**SITE PLAN REVIEW COMMITTEE
MEETING AGENDA**

DATE: Monday, October 27, 2014
TIME: 7:00 – 8:25 p.m.
PLACE: 2100 Clarendon Boulevard
Courthouse Plaza, 1st Floor, Cherry and Dogwood Rooms
Arlington, VA 22202

SP #435 2025 Clarendon Boulevard (Wendy's/Wells Fargo)
(RPC# 17-011-011, -012)

Deviations from Site-Specific Guidance (pp.26-27):

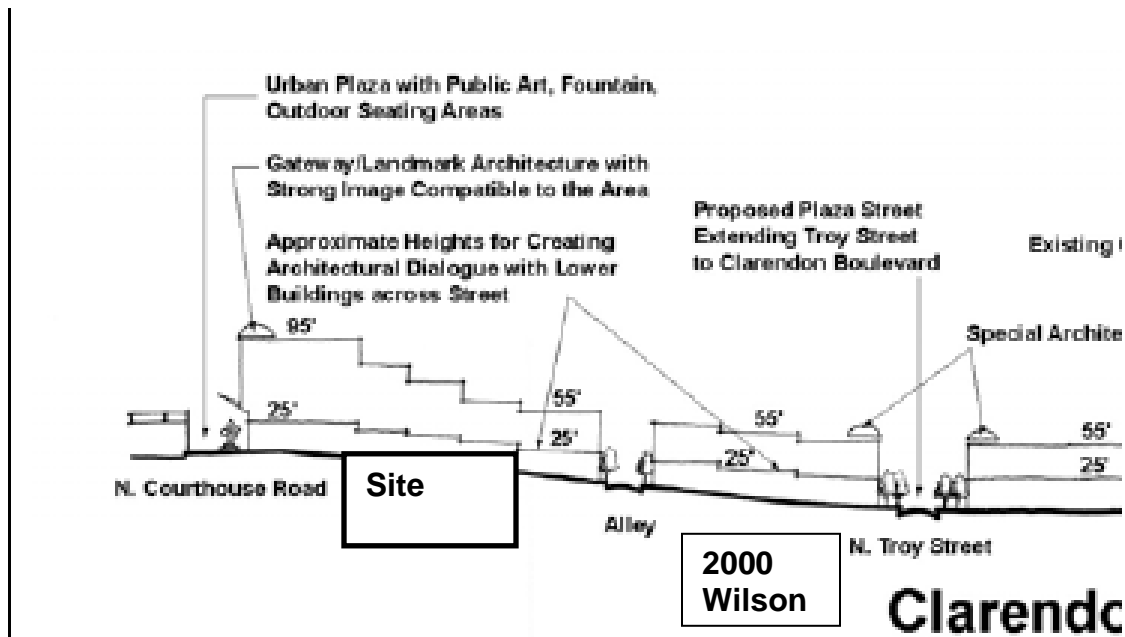
- “Buildings no higher than 10 stories generally, except vertical architectural elements at the western end.”
 - The proposed building is 12 stories. However, the *Study* also states that “Flexibility in heights could be approved to accommodate affordable housing, community facilities, special design considerations and or/new streets (p. 19).”
- “Horizontal treatment at the top of the second floor is encouraged to relate to historic buildings across Wilson Boulevard.”
 - While not in the “site specific guidance”, the *Study* additionally recommends a step back of at least 20 feet on the second level. Instead, the proposed building actually widens by 6.5 feet above the second story.
